TO: Stephen Scott, Principal Planner, City of San Mateo
FROM: David Parisi, Parisi Associates
DATE: July 25, 2012
SUBJECT: Directed Self-Parking Plan for St. Matthews (356-Plus Parking Plan)

Subject: Saint Matthew's Directed Self-Parking Plan (356 Plus)

SAINT MATTHEW'S 356-PLUS PARKING PLAN

Sheet Title
PARKING PLAN
TOTAL SITE

Sheet Number
C-6

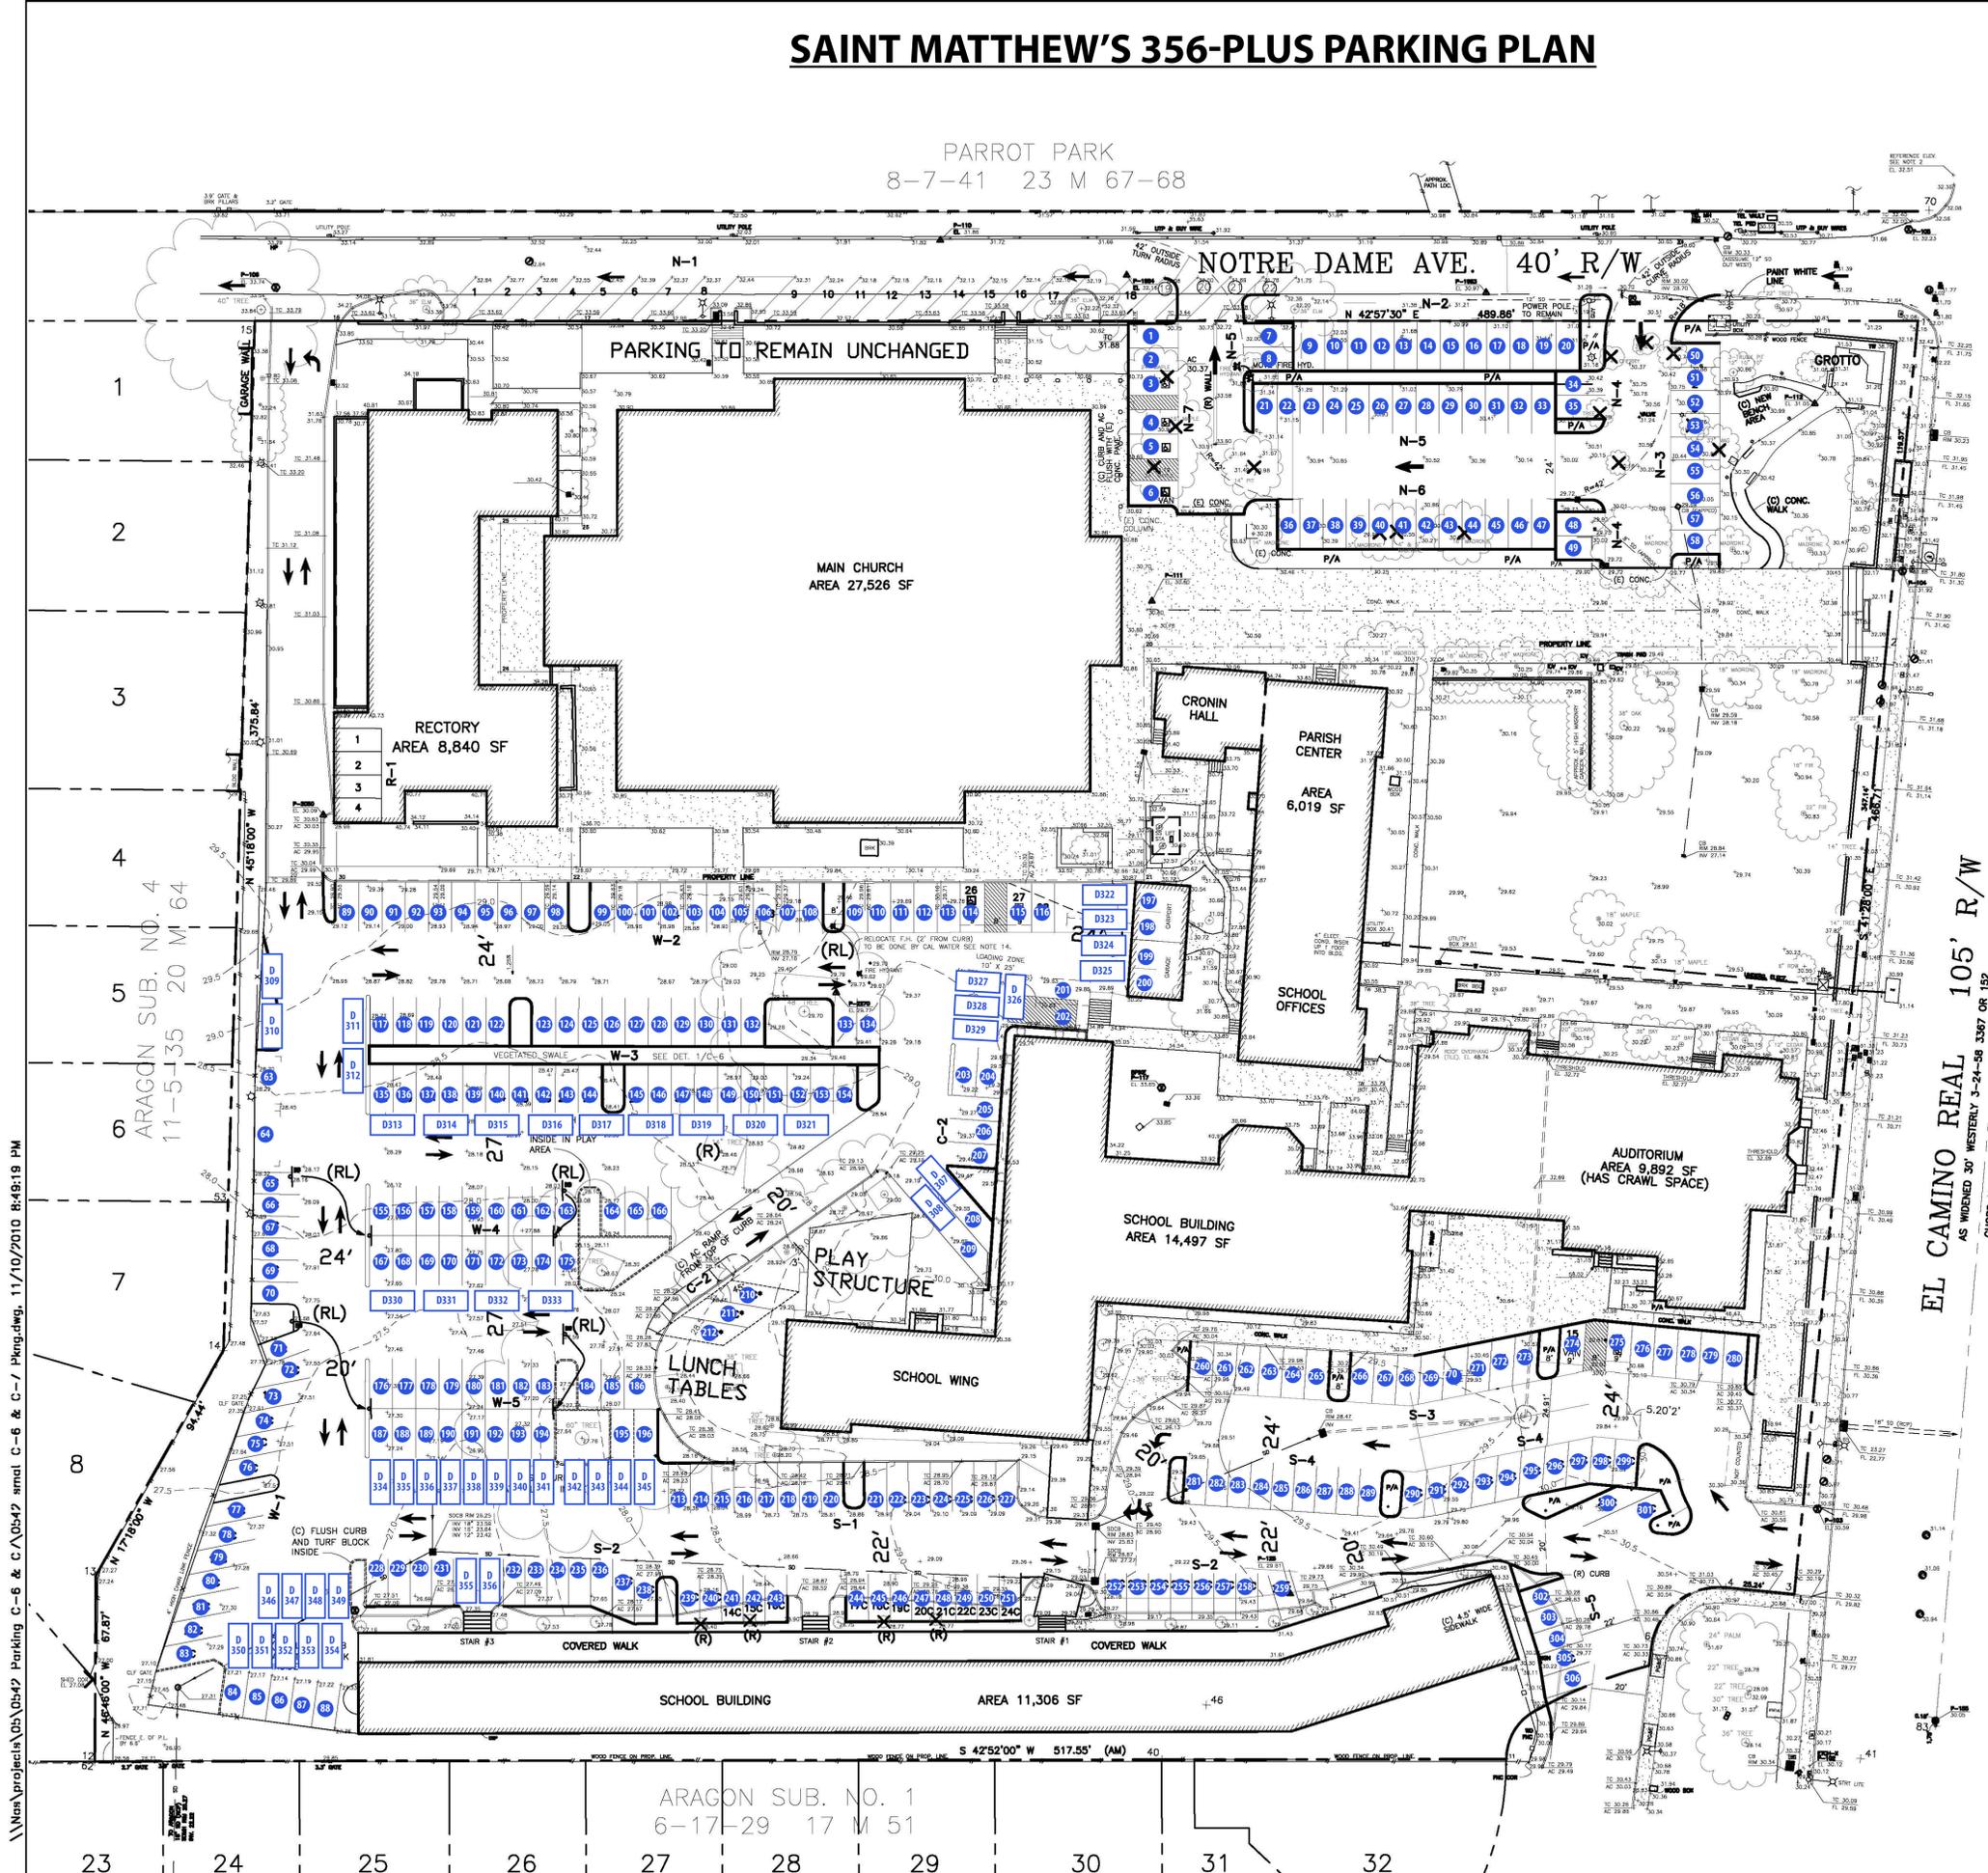
1. The overall design seems very effective at using the available space to maximize the number of parking spaces. I cannot imagine that any other configuration would result in a larger number of parking spaces.

2. Based on the layout and actual size of each parking space, along with the width of the parking lanes between rows, I do not foresee any issues with people being able to easily self-park themselves in all the designated areas.

3. Regarding the proposed directed self-park spaces, I do have some recommendations:
 - Space #307 and #308 should be relocated from the Notre Dame parking lot to next to the play structure. Due to the nature of directed self-parked cars blocking in other vehicles, it is required that all vehicles be supervised to be able to unblock self-parked guests as needed. Provision of two directed self-park spaces in the Notre Dame lot would not provide enough value to warrant the added labor cost of one attendant designated to that area.

- Spaces #309-312 and Spaces #355-356 – six parking spaces – can remain as "un-lined parking spaces"; these spaces should be used for self-parking since these cars will not be blocking in any other vehicles. Again, the idea is to minimize and centralize the areas supervised by attendants so as to reduce the number of attendants and overall labor needed to operate the parking lot.

- Forty-four (44) added directed self-park spaces would remain centralized into five separate attendant areas or lanes that can each be managed by one attendant each. I would recommend five attendants to direct cars to all available self-parking areas, then provide "overflow" service with each attendant managing a specific area that contains either four, nine, nine, 10 or 12 directed self-park spaces (44 total). The attendant managing only four cars can assist the attendant managing 12 cars (as needed), since these areas are next to each other and within close eye-sight.

- From my experience, perpendicular stack parking on one side of each of the two 27-foot wide lanes, while still maintaining a 20-foot fire lane, should not prevent vehicles on the opposite side of the lane from backing out of a directed self-parking space and not have enough room to exit. As shown on the map by the absence of additional self-park spaces, perpendicular stacking is not advised in 24-foot wide (or narrower) lanes since less than the mandatory 20-foot fire lane will remain.

- The "nose-to-tail" parking used for spaces #334-345 would work for directed self-parking without any problems, as long as the remaining parking lane will still meet the minimum requirement of a 20-foot fire lane.

4. As with all directed parking operations that are co-mingled with self-parking areas, instructions should be communicated to those using the parking to please be cautious and be patient when exiting the parking areas. Due to the presence of stacked vehicles, drivers must use extra caution when backing out of self-parking spaces to avoid any collisions. Drivers should be informed to please error on the side of caution and alert an attendant to assist them when a stacked vehicle needs to be moved. Guests using the directed self-parking service should be patient and allow the attendants to assist all guests one at time.
